February 13, 2019 SGTF Presentation - “Operational Assessment Process Could Safely Replace Existing Prescriptive Technical Specification Inspection Intervals”

Rick Maurer's Comments:

Plant B Operational Assessment Example for Axial PWSCC

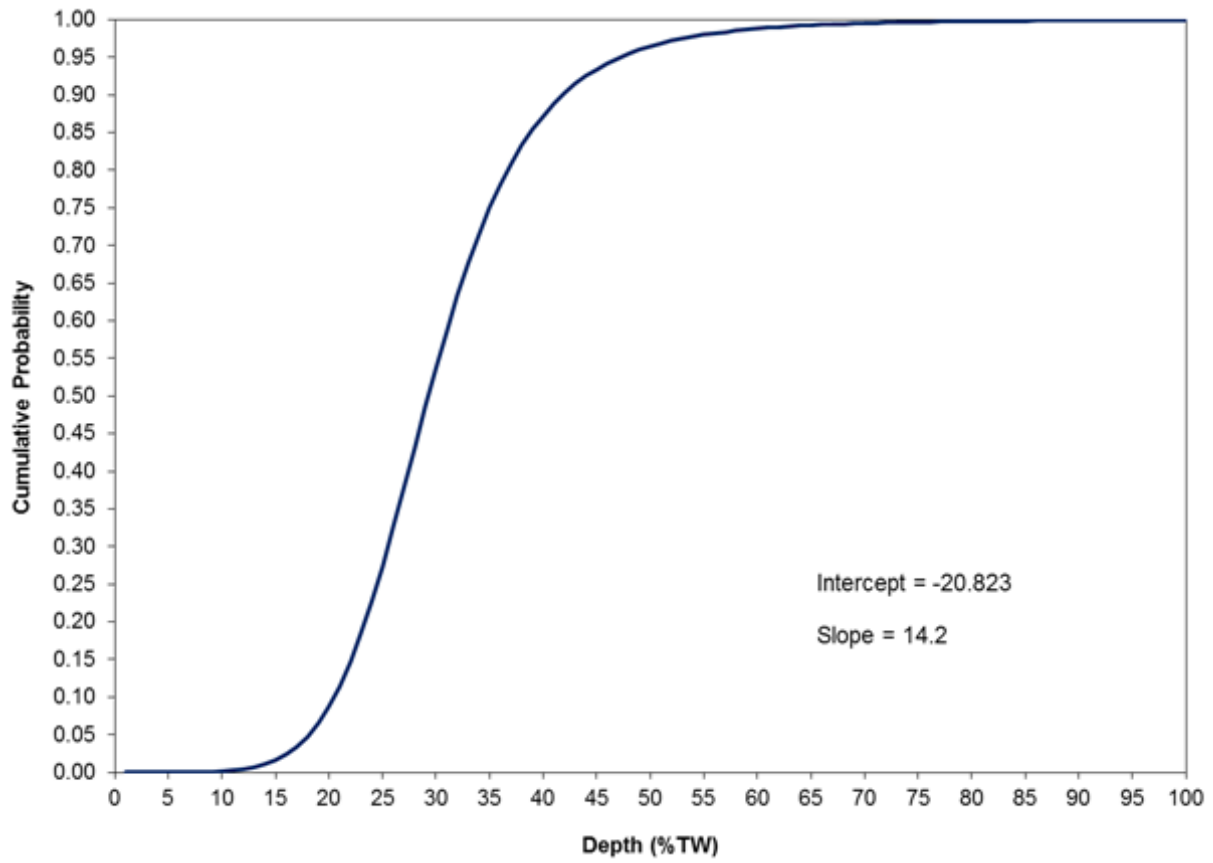
- The third bullet on slide 27 states: “Expect that only a limited number of crack indications with minor severity will be occasionally observed in the future”. The term “minor severity” is an appropriate generalization for the majority of the cracks but there are some notable exceptions.

- Had these units skipped the inspections during which these flaws were detected the cracks would presumably have continued to grow and could have potentially challenged tube integrity over the period of the subsequent operating interval.
